**LEVY NUCLEAR PLANT, UNITS 1 AND 2  
DOCKET NOS. 52-029 AND 52-030  
RESPONSE TO REQUEST FOR ADDITIONAL INFORMATION LETTER NO. 097 RELATED TO  
SRP SECTION 2.4.12 FOR THE LEVY NUCLEAR PLANT UNITS 1 AND 2 COMBINED  
OPERATING LICENSE APPLICATION**

**Levy Nuclear Plant Units 1 and 2  
Response to NRC Request for Additional Information Letter No. 097 Related to  
SRP Section 2.4.12 for the Combined License Application, dated January 5, 2011**

**NRC RAI NUMBER:** 02.04.12-25

**FIGURE 1**

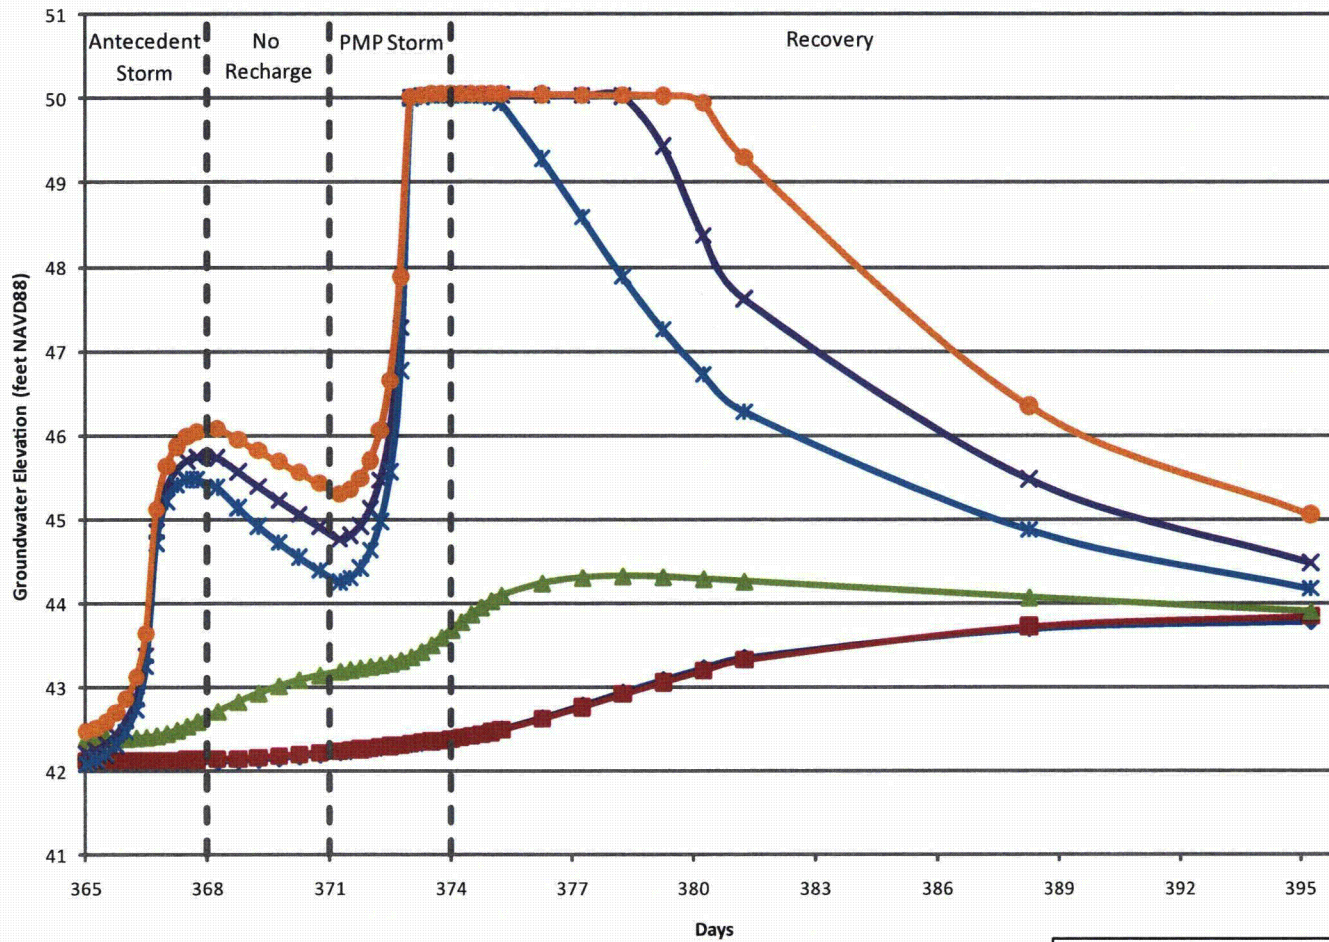
As result, the applicant is requested to provide an estimate of the maximum post-construction groundwater level that is based on anticipated post-construction surface conditions, the anticipated properties of the fill material, the conceptual model of the subsurface, and expected maximum recharge rates. This estimate must be based on specific recharge rates associated with the main surface features, including any semi-impervious surfaces, gravel-covered surfaces, and grass-covered surfaces. The applicant's estimate must also be based on the post-construction elevation and capacity of the surrounding stormwater drainage ditches and ponds, and the post-construction geology including properties of engineered fill and backfill. In its response, the applicant is requested to provide proposed updates to the FSAR, which would include the results of this analysis and supporting information used in the analysis.

The results of this evaluation indicate that a pervious area infiltration rate equivalent to the maximum hourly PMP rate (3.57 inches/hour) will not result in groundwater elevations exceeding 14.9 m (49 ft) NAVD88 at safety-related structures, although groundwater elevations exceeding 14.9 m (49 ft) NAVD88 were generated in the model at some locations of the site. RAI 02.04.12-25 Figure 1 (Attachment RAI 02.04.12-25A) and RAI 02.04.12-25 Figure 2 (Attachment RAI 02.04.12-25B) present these results.

The results presented in RAI 02.04.12-25 Figures 1 through 4 (Attachments RAI 02.04.12-25A through Attachment RAI 02.04.12-25D) are conservative. Groundwater elevations of 50 feet would not realistically be expected within the pervious areas of the site because groundwater would move down the topographic slope via overland flow once the groundwater surface intersected the ground surface.

infiltration rates at the pervious areas of the LNP site would result in groundwater elevations similar to those depicted on RAI 02.04.12-25 Figure 1 and Figure 2 (Attachment RAI 02.04.12-25A and Attachment RAI 02.04.12-25B, respectively) because the rise in groundwater elevations would be limited by the precipitation rate, not the infiltration rate.

The results of this evaluation indicate that a pervious area infiltration rate equivalent to the maximum hourly PMP rate (3.57 inches/hour) will not result in groundwater elevations exceeding 14.9 m (49 ft) NAVD88 at safety-related structures, although groundwater elevations exceeding 14.9 m (49 ft) NAVD88 are simulated at some locations of the site. RAI 02.04.12-25 Figure 1 and RAI 02.04.12-25 Figure 2 present these results.

The results presented in RAI 02.04.12-25 Figure 1 and RAI 02.04.12-25 Figure 2 are conservative. Groundwater elevations of 50 feet would not realistically be expected within the pervious areas of the site because groundwater would move down the topographic slope via overland flow once the groundwater surface intersected the ground surface.
